Rutland City BRF 3000 (2014036)  
SUBMITTAL 16.2

Topic EPSC Plan Revision-BR 2 Cofferdam Dewatering  
Status For Approval  
Spec section 652.10 EPSC Plan BR 2  
Sent to approver 4/1/15  
Required from approver 4/8/15

**STAGE 4 EROSION CONTROL PLAN 1**

**EC15<sub>R</sub>**

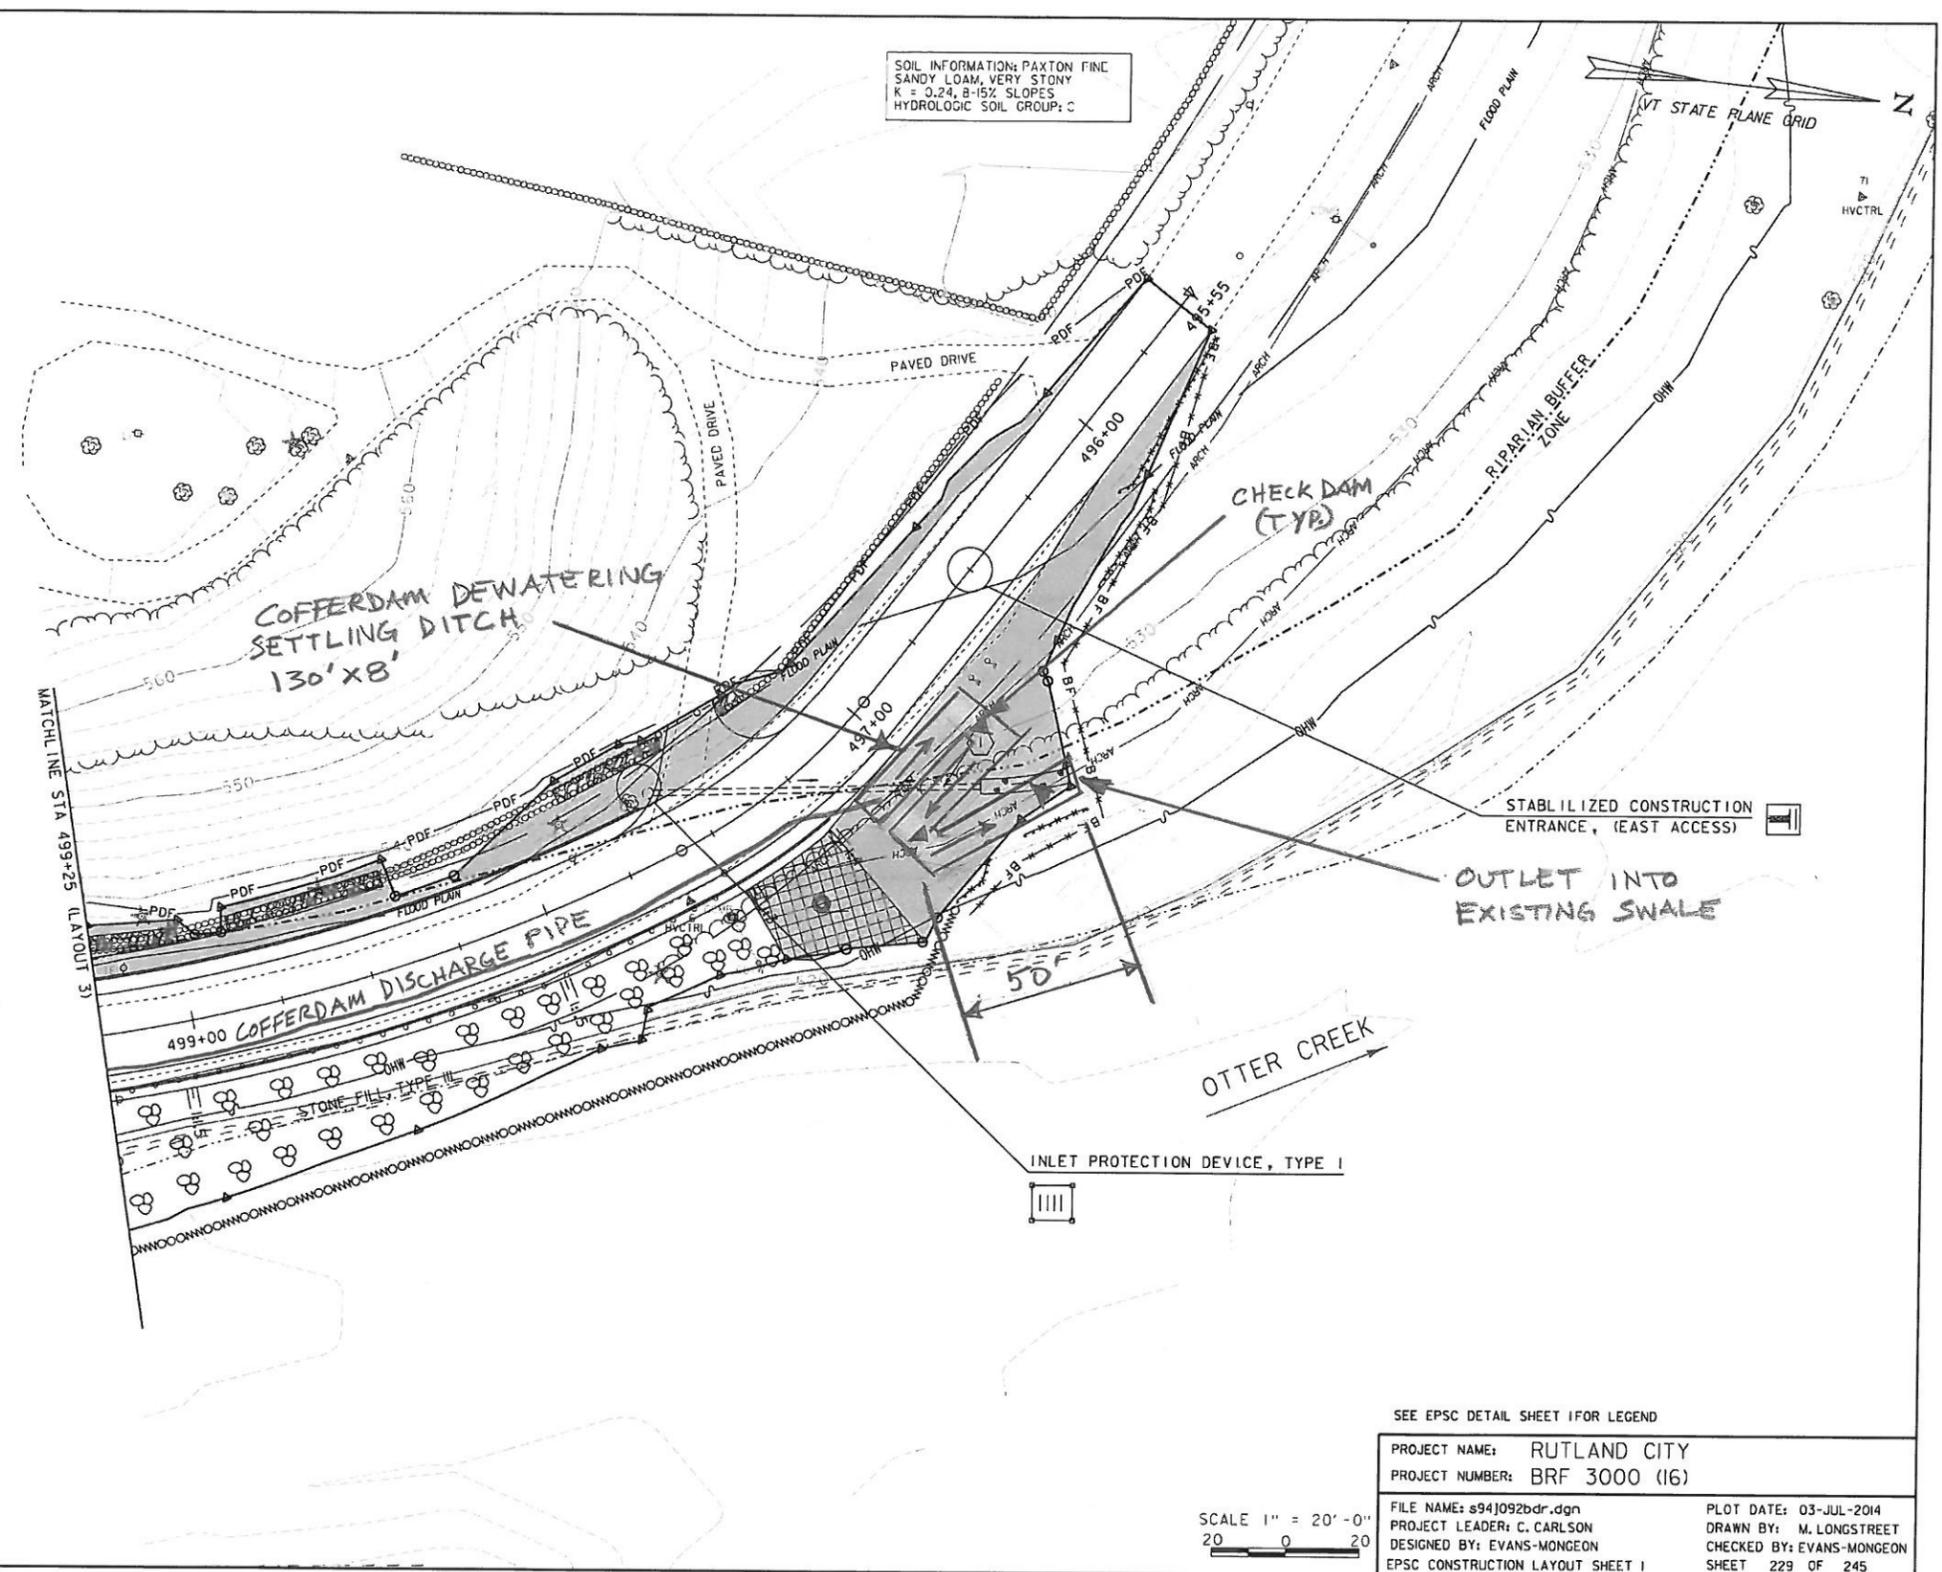
Message Tim,  
Please find the attached, revised sheet EC15 of our erosion control plan. This revision addresses the handling of water pumped out of our cofferdam. We propose to let sediment settle through an approximately 130' long ditch located at the north end of the project (STA 497+00). A temporary stone lined ditch will incorporate check dams and will out let at the same location as the permanent culvert pipe. This out let location will allow water to continue to flow through an existing swale before eventually entering the Otter Creek. If you need any additional information, please let me know.  
Thank you,  
Volker

Proceed as Indicated
